# DESCRIPTIVE REPORT

H11467

Approaches to Portland

# ATLANTIC HYDROGRAPHIC BRANCH PREFACE NOTES FOR PORTLAND, ME COMBINED SURVEY

Figure 2.2.1

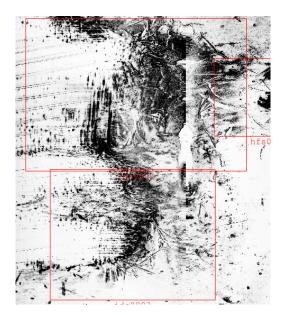
Chart a dangerous obstruction (fouling with piles), least depth unknown, in 43°39'35.968" N, 70°14'37.434" W.

*Figure 4.3.1*

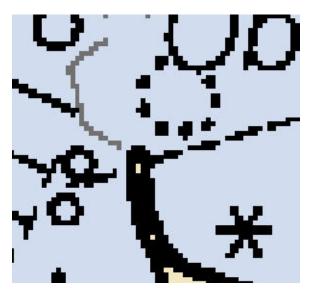
As per DTON submission, a dangerous obstruction, least depth five feet in Latitude 43°39'04.370" N, Longitude 070°13'42.090" W is shown on chart 13292, 37th., Aug. /04 and charted pier extension in the vicinity of Latitude 43-39-05.559 N, Longitude 70-13-39.761 W has been deleted from chart 13292, 37th., Aug. /04. Retain as charted. It is also recommended that the area be delineated as a foul area with text "Ruins" charted in the vicinity.

Figure 5: Charting Recommendations for Foul Area

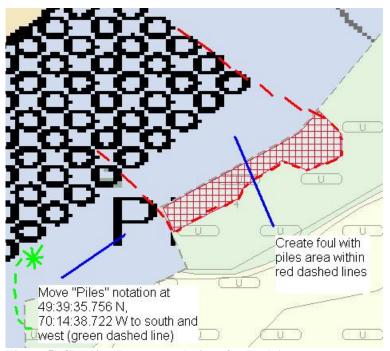
Review of side scan sonar data found fouling with piles centered in location 43°39′36.96″ N, 70°14′34.82″ W. These ruins appear to be connected to a large area of charted piles at 43°39′37.83″ N, 70°14′37.20″ W. The office processor recommends charting a foul area with piles as shown in Figures 5 and 6 below and moving the charted notation "Piles" to the south and east. This area is in the H-Cell as an obstruction area object (OBSTRN, foul ground), with the limits of the area object being the limits of side scan sonar coverage. The obstruction area object is shown in Figure 5 as a red hashed area.

Figure 7: Inadequate Object Detection Regions

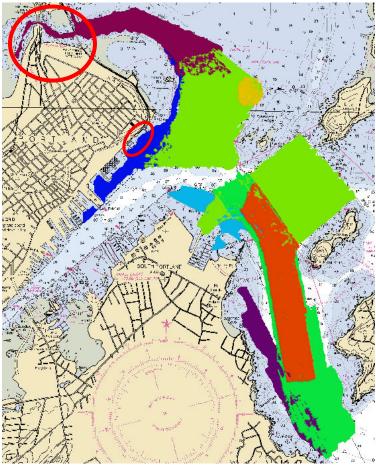
The present survey is adequate to supersede the charted hydrography within all common areas except the red-circled areas shown in Figure 7. In these areas, bathymetry coverage is adequate but object detection specifications were not met as coverage was acquired with VBES only. The hydrographer recommends retaining all charted features in this area that are not otherwise discussed in this report. Otherwise, this is an adequate navigable area survey. Except as noted elsewhere in this report, no additional field work is recommended by the office processor.
